AIWA CO.,LTD
UTSUNOMIYA FACTORY

SERVICE TECHNICAL INFORMATION

UTSUNOMIYA, APRIL 30, 1996
REF. NO. : SI-96-006
CUSTOMER RELATIONS & SERVICE DIV.

MODEL : AM - F3
SUBJECT : Improving servo operations when recording
SYMPTOM : Because servo operations during recording are sometimes unstable, when playing the disc after recording, there are cases in which the recording was made in a dropout condition.
REMEDY : In order to improve servo operations, replace the 5 parts listed below.
(Refer to the figure on the next page for the arrangement of parts on the board.)

PARTS LAYOUT

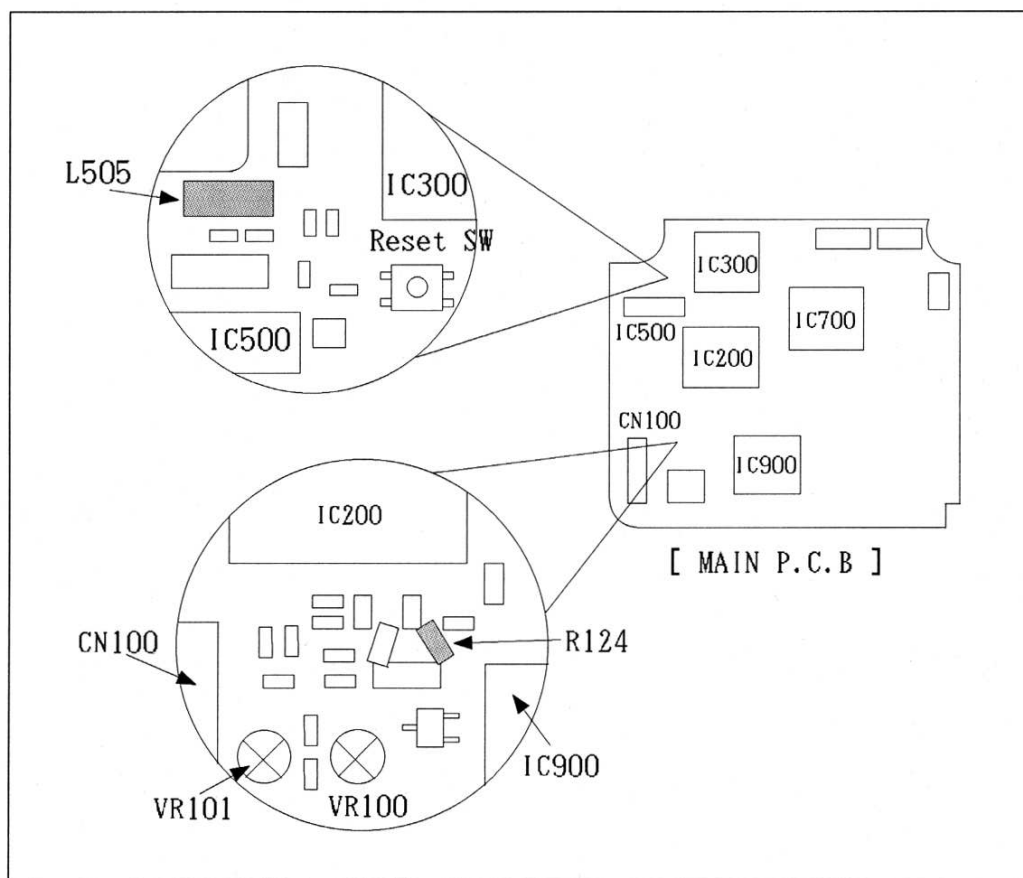
| Part No. | Part Name | Contents | Ref. No. |
|----------------|---------------------|--|----------|
| 87-A50-108-080 | C-COIL 33 μ H | 10 μ H \rightarrow 33 μ H | L505 |
| 87-010-787-080 | C-CAP 0.022 μ F | 0.047 μ F \rightarrow 0.022 μ F | C120 |
| 87-010-829-080 | C-CAP 0.047 μ F | 0.1 μ F \rightarrow 0.047 μ F | C121 |
| 88-108-183-080 | C-RES 470K- 1/16W | 680K and 390K Ω \rightarrow 470K Ω | R100 |
| — | — | Remove 18K Ω | R124 |
